HISTORIC AND DESIGN REVIEW COMMISSION

HDRC CASE NO: 2020-389
ADDRESS: 618 BROADWAY
LEGAL DESCRIPTION: NCB 441 BLK 7 LOT 4
ZONING: FBZ T6-1, RIO-2
CITY COUNCIL DIST.: 1
APPLICANT: Jonathan Card/CARD AND COMPANY Architects pllc
OWNER: JAMES SHAW/MISSION DOWNTOWN LLC
TYPE OF WORK: Exterior alterations
APPLICATION RECEIVED: August 28, 2020
60-DAY REVIEW: Not applicable due to City Council Emergency Orders
CASE MANAGER: Edward Hall

618 BROADWAY

HDRC Submission for Certificate of Appropriateness

PROPOSED: 618 BROADWAY STREET ELEVATION

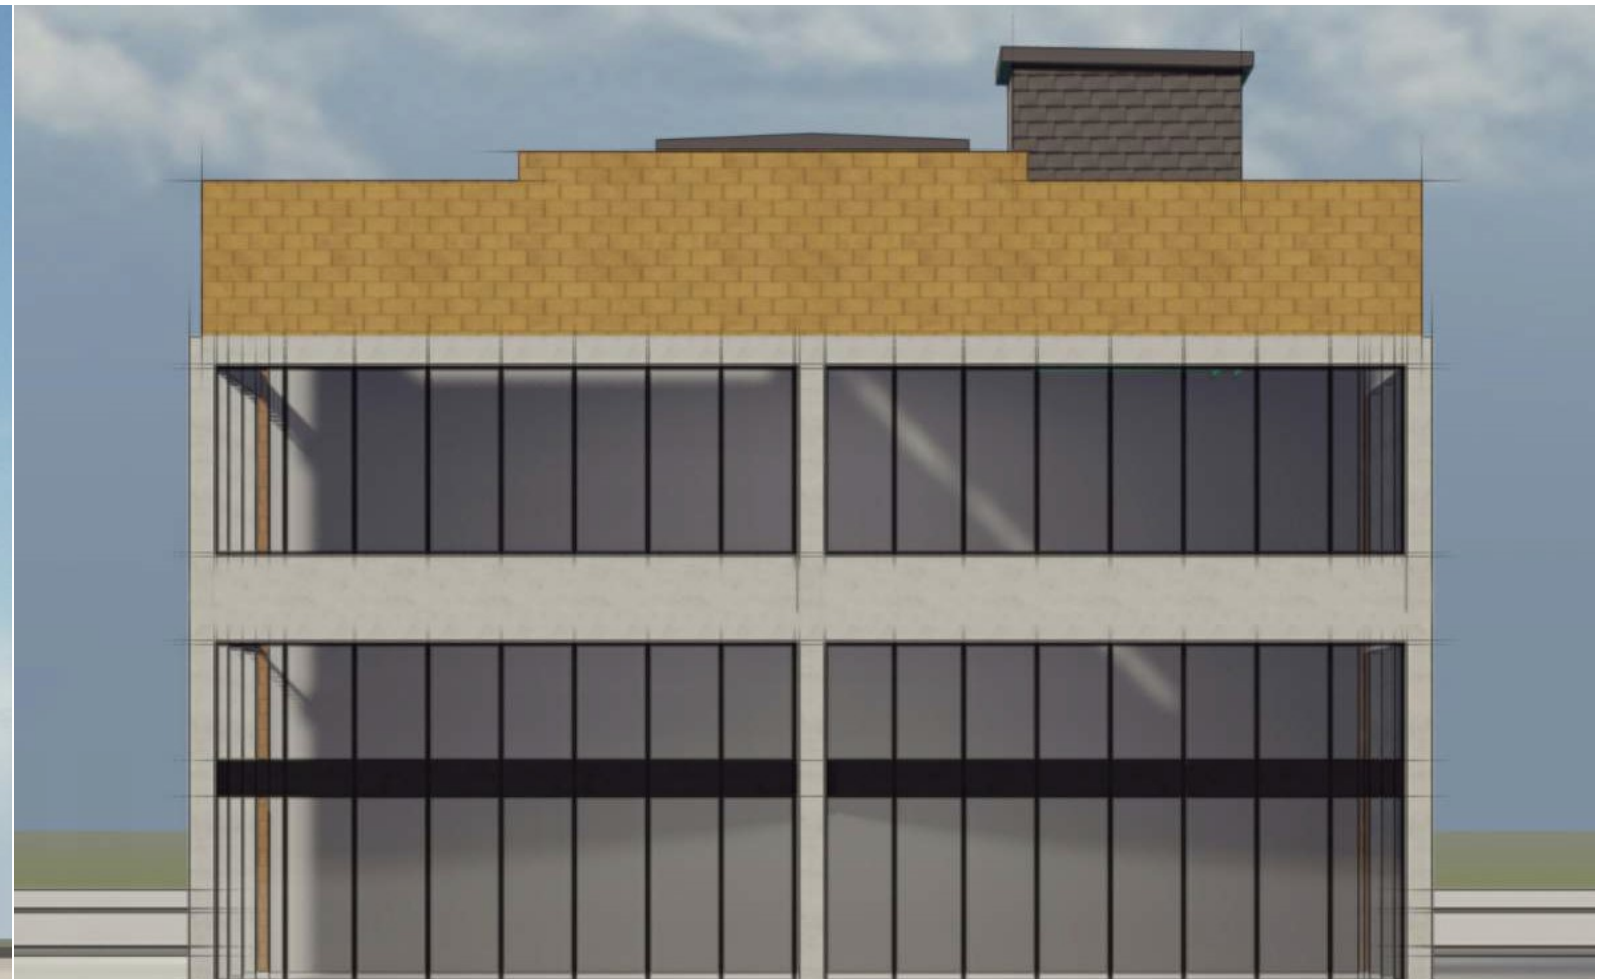
- d. STEEL CANOPY INSTALLATION – The applicant has proposed to install a new steel canopy on the Broadway façade. Per the submitted construction documents, staff finds the proposed profile and location of the canopy to be appropriate. Staff finds that a canopy detail should be submitted to staff for review and approval prior to the issuance of a Certificate of Appropriateness.

- e. STOREFRONT SYSTEM (West façade) – The applicant has proposed to remove the existing, non-original storefront system and install a new storefront system on the Broadway (west) façade. Within this, the applicant will modify the existing, non-original knee wall height. Staff finds the proposed scopes of work to be appropriate. Existing knee wall heights of adjacent historic structures are shorter than the modified height. The applicant has proposed for the new storefront system to include aluminum clad wood windows, with aluminum windows and sidelites at a proposed recessed entry. While staff finds the proposed replacement to be appropriate, staff does not find the modification to the profile (recessed entrance) to be appropriate. Staff find that there is no historic information to support this request.

- j. SIGNAGE – The applicant has shown signage on the Broadway façade; however, the proposed signage is noted as conceptual in only placement and design. Generally, staff finds the overall location and size of the proposed signage to be appropriate and consistent with the UDC. The proposed signage is to return to the Commission for final approval.

- i. That all work be done in-kind, with like materials.
- ii. That a canopy detail be submitted to OHP staff for review and approval prior to the issuance of a Certificate of Appropriateness.
- iii. That the recessed entry be eliminated from the new storefront system.

Staff recommends conceptual approval of item #9, signage, with the stipulation that final signage documents return to the Commission for final approval.

PROPOSED SOUTH ELEVATION

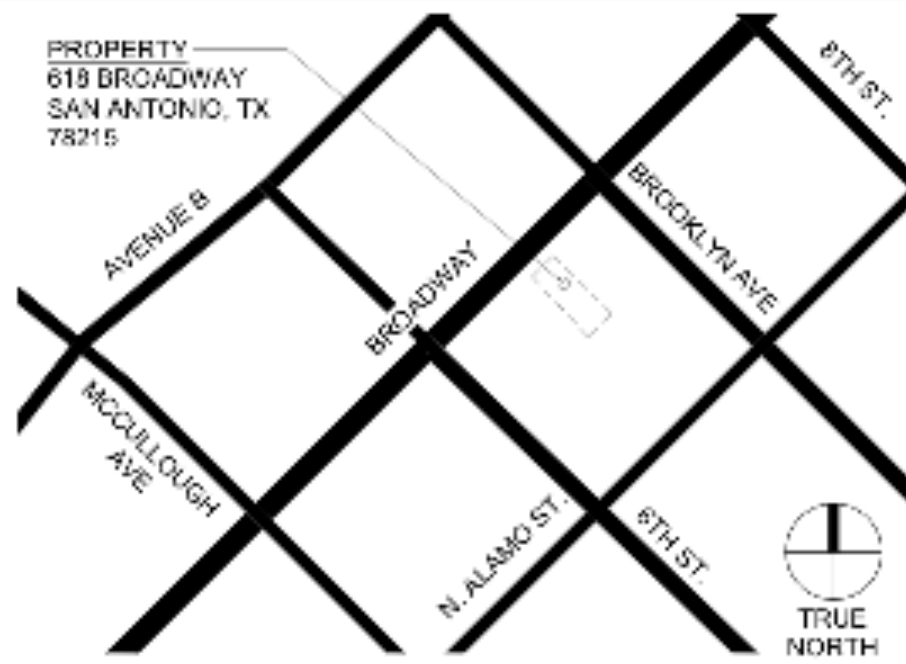
- h. STOREFRONT SYSTEM (Steel windows) – The applicant has proposed to install storefront systems over the existing side steel windows on each façade. The existing steel windows and their openings will remain. Staff finds this request to be appropriate.

Staff recommends approval of items #6 through #8 as submitted.

4 DEMOLITION - SOUTH ELEVATION
SCALE: 1/8" = 1'-0"

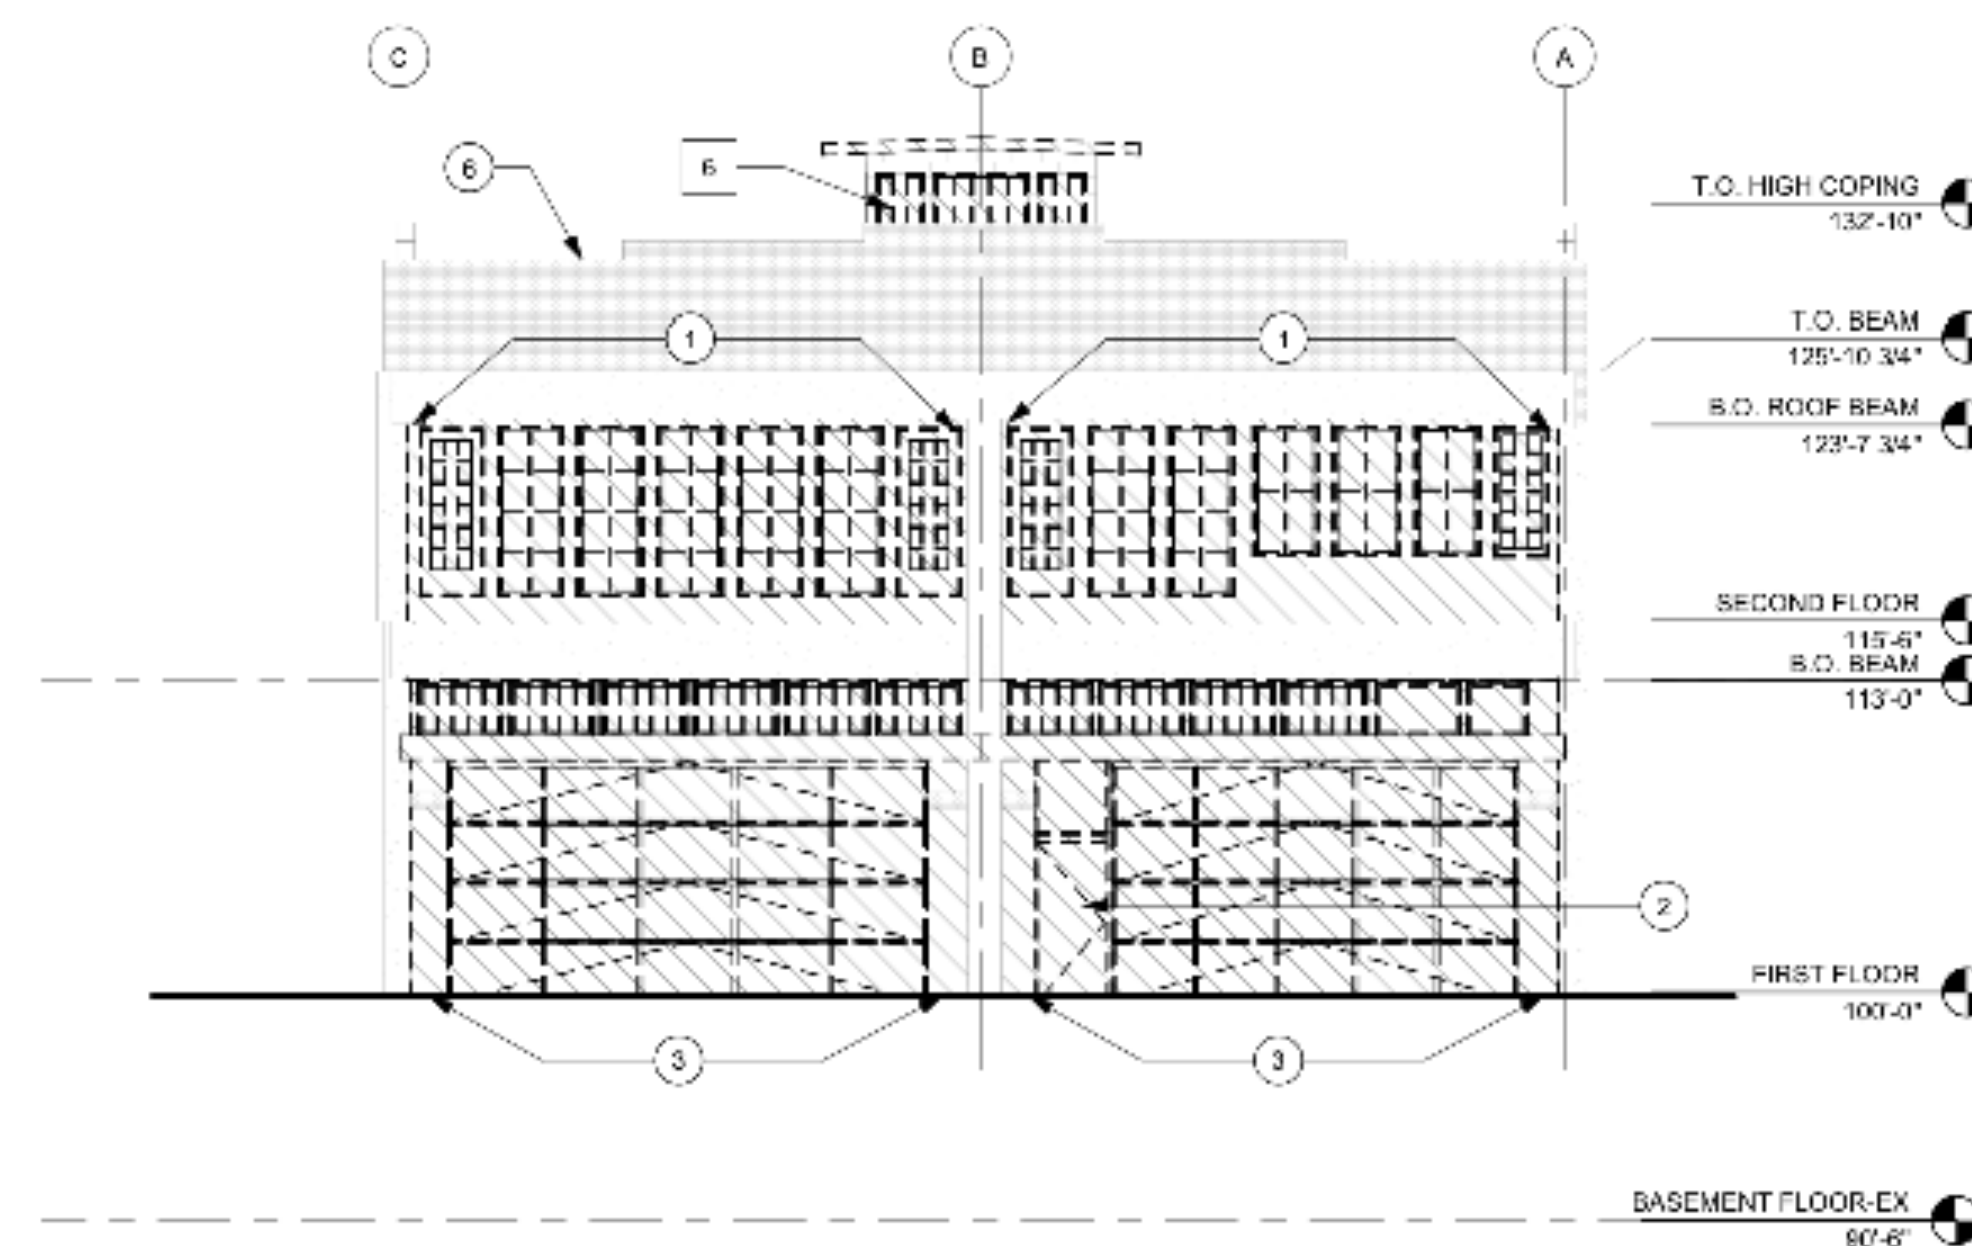
- f. EXTERIOR MODIFICATIONS (East façade) – The applicant has proposed to modify the east façade by removing all existing wood windows, garage doors and CMU infill on the east façade and replacing them with new windows and garage doors. While the east façade is a rear façade, staff finds that original windows openings and façade profiles should be maintained, per the UDC Section 35-676. Staff finds that the existing wood windows should be repaired. Staff finds the replacement of the non-original garage doors to be appropriate; however, the profile of the openings should not be modified.

Staff does not recommend approval of item #5, window replacement and exterior modifications to the rear (east) façade. Staff recommends that all wood windows be repaired and reinstalled. Staff finds the replacement of the garage doors to be appropriate; however, the openings should remain as they exist.
